Technical Service Information

THM 440-T4 NO TCC APPLY OR TCC SHUDDER

Figure 1

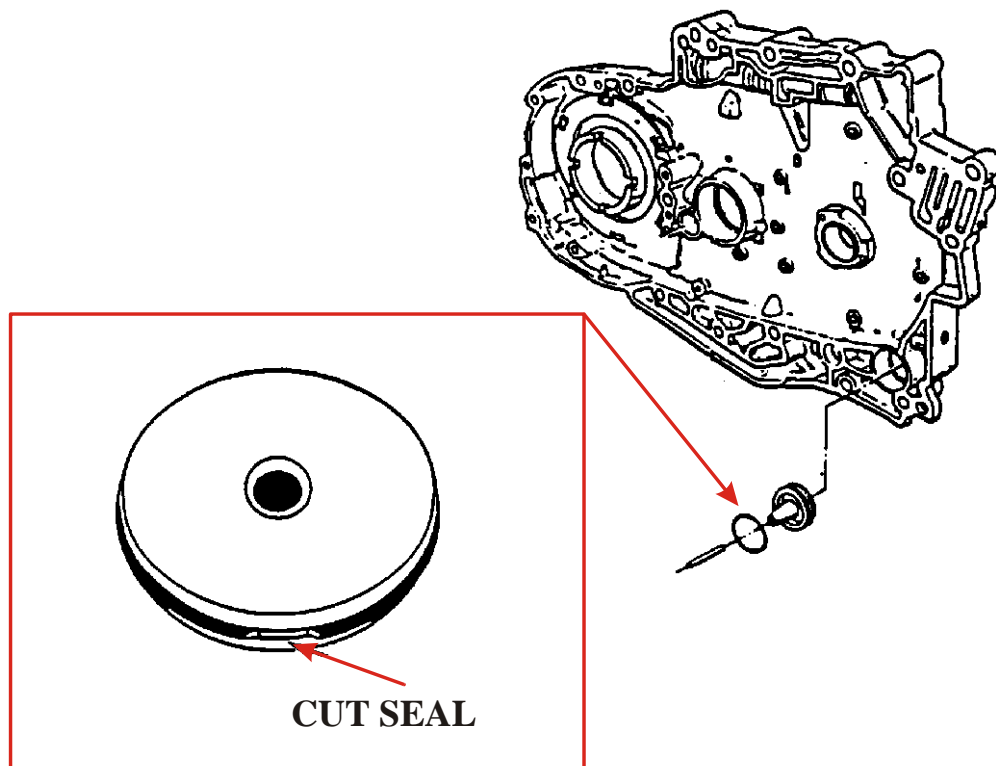
CAUSE: Some 1984 and some early 1985 THM 440-T4 transaxles may experience a no Torque Converter Clutch (TCC) apply or TCC shudder condition, which may be due to a cut or rolled TCC accumulator piston seal (See Figure 1).

CORRECTION: Install updated service package 8646926. Updated service package 8646926 contains the followings

- 1.1-TCC ACCUMULATOR PISTON
- 2.1-TCC ACCUMULATOR PISTON PIN
- 3.1-TCC ACCUMULATOR PISTON SEAL
